SUBDIVISION REPORT - CONCEPT/DEVELOPMENT PLAN

▶ **FILE #:** 6-SB-23-C

▶ **SUBDIVISION:** CRUZ FARMS

▶ **APPLICANT/DEVELOPER:** URBAN ENGINEERING, INC.

SHEET C-2

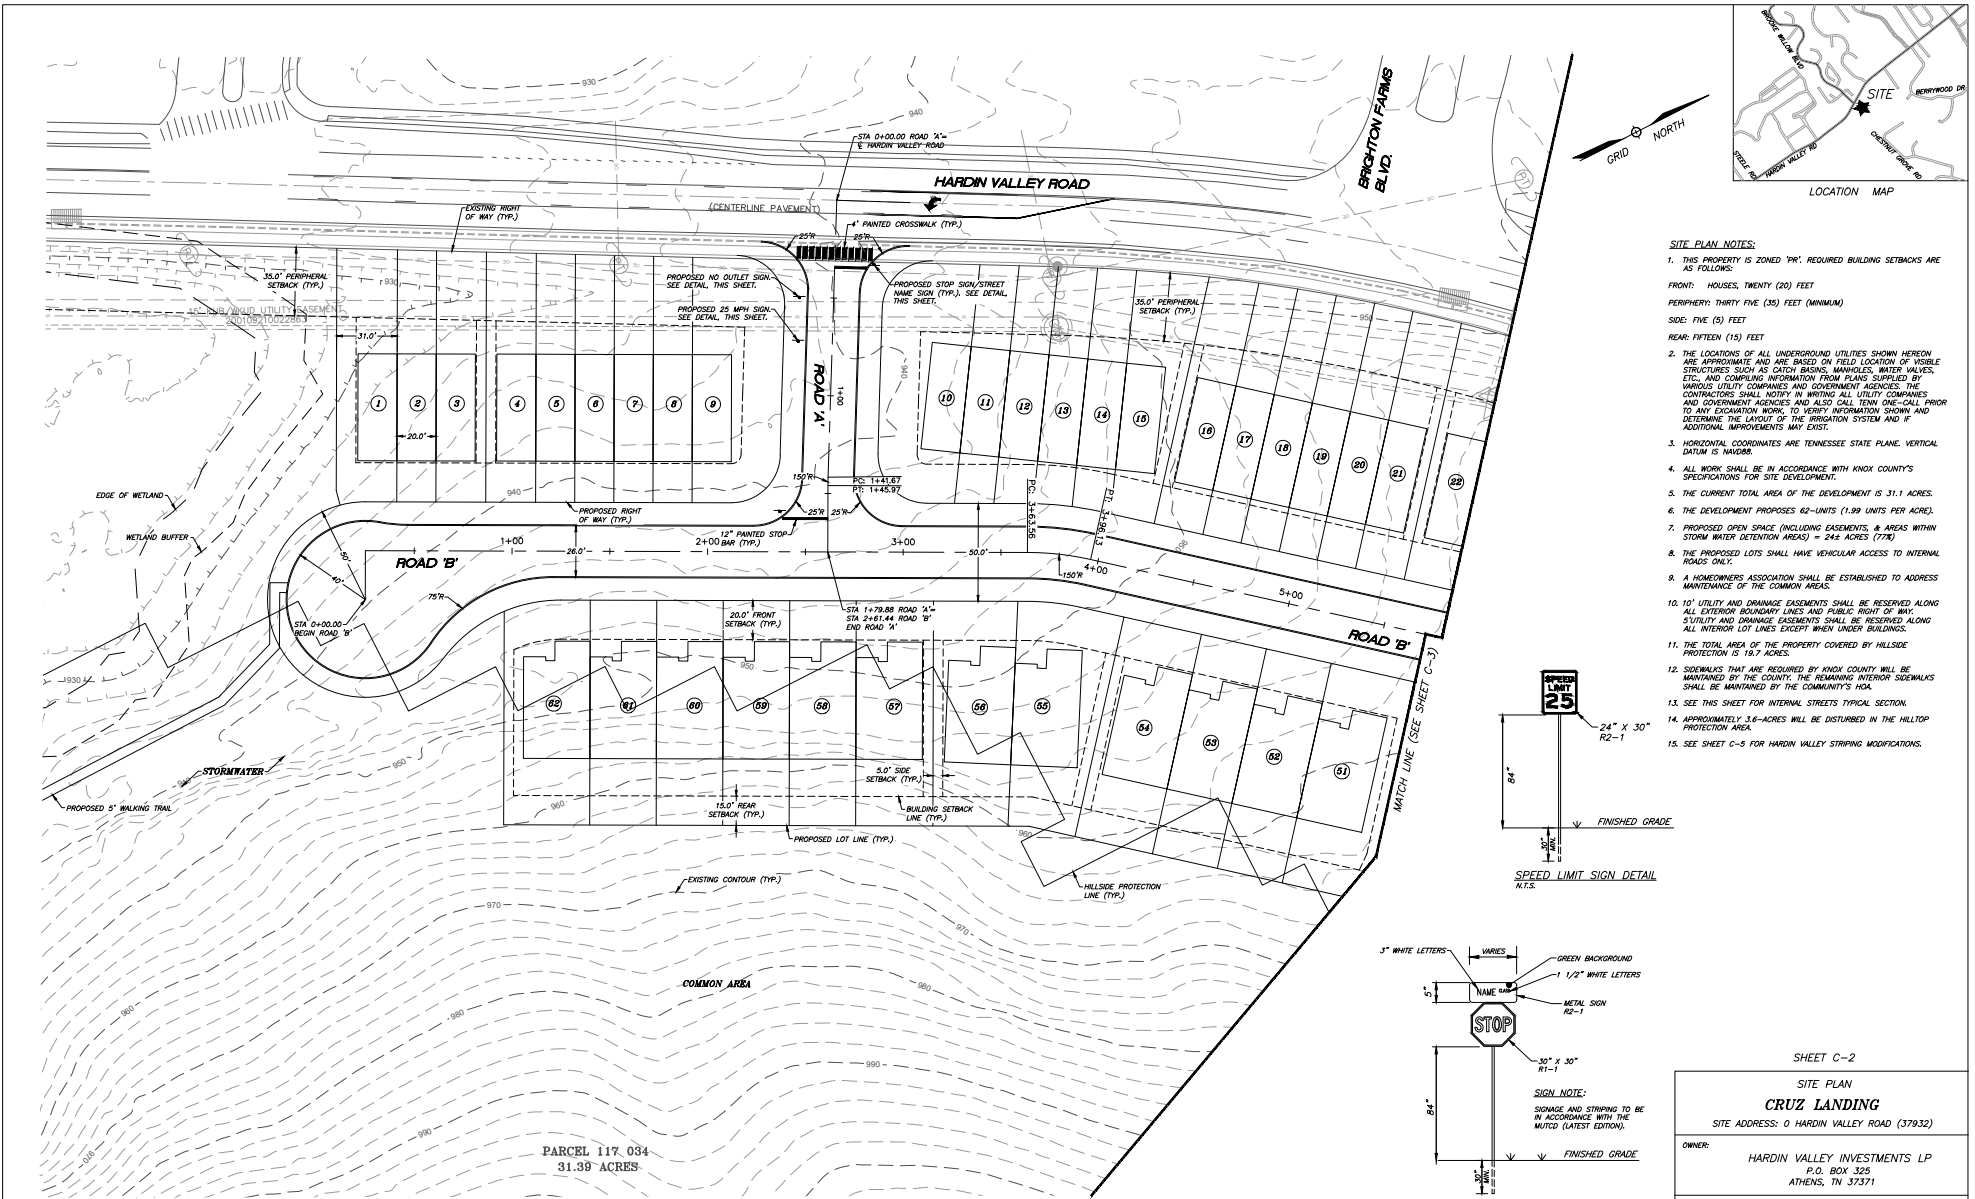
- ▶ **Approve the requested variances and alternative design standard based on the justification provided by the applicant and recommendations of the Knox County Department of Engineering and Public Works.**

Approve the Concept Plan subject to 8 conditions.

- 3) Certifying that the minimum sight distance can be obtained to the east along Hardin Valley Drive at the Road 'A' access point during the design plan phase and before grading permits are issued.

- 6) Providing a sidewalk on Road 'A'.
- 7) Meeting all applicable requirements of the Knox County Department of Engineering and Public Works.
- 8) Before certification of the final plat for the subdivision, establish a property owners association or other legal entity responsible for maintaining common facilities, such as common areas, amenities, private roads, and/or stormwater drainage systems.

The minimum intersection separation is 400 ft on arterial streets, measured from the centerline of each intersection. The intersection separation to Brighton Farms Blvd to the east is 290 ft, and to Brooke Willow Blvd to the west is 310 ft. The traffic study details how the center turn lane has to be restriped to provide the required queuing length. The proposed intersection separation provides adequate space for the turn lanes, and

SHEET C-4

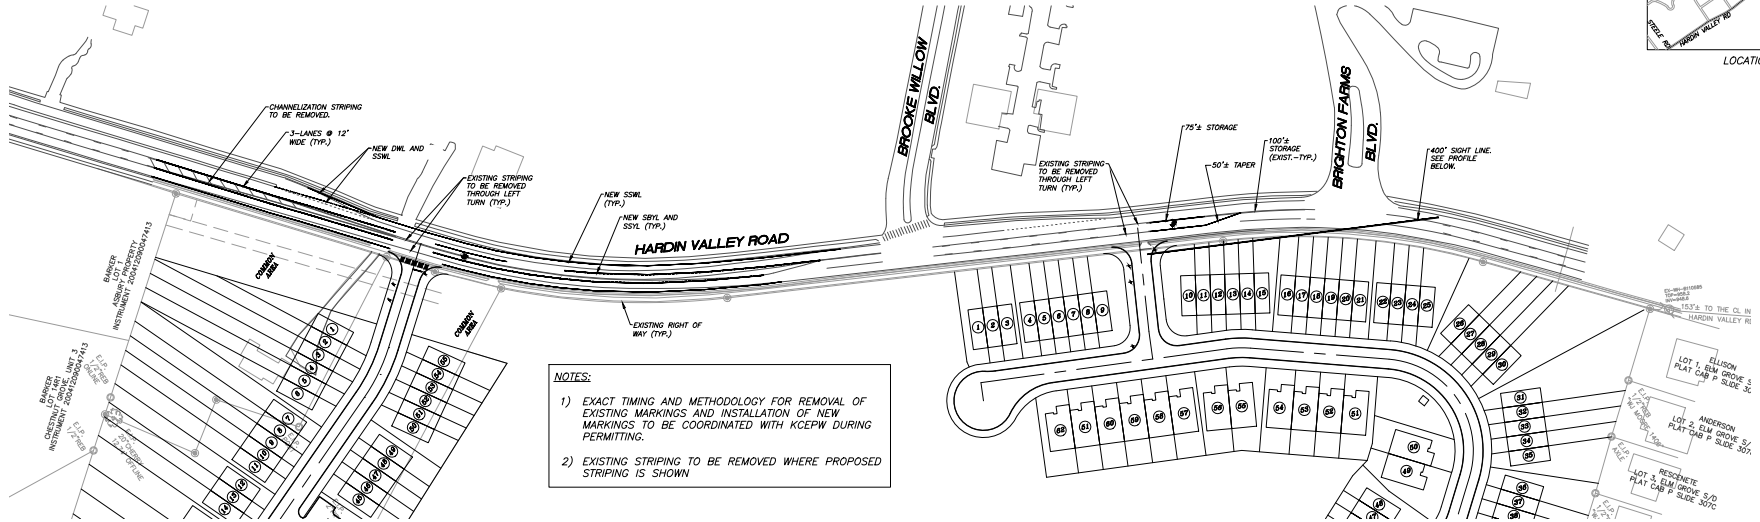
1. Increase the maximum intersection grade from 1 to 2 percent on Road 'A' at the Hardin Valley Road intersection
2. Increase the maximum intersection grade from 1 to 2 percent on Road 'A' at the Road 'B' intersection

Approve as requested since no unsafe conditions are created.

SHEET C-5

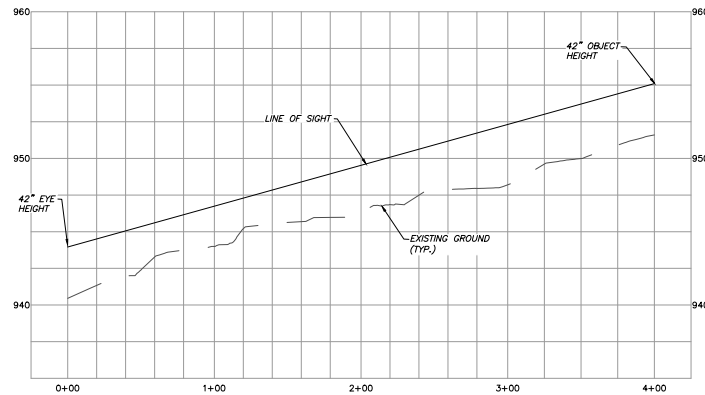
A left turn lane is required, which will require restriping the existing middle turn lane. A consistent middle turn lane will also be striped west of Brooke Willow Blvd. The restriping will not require the pavement width of Hardin Valley Drive to be widened.
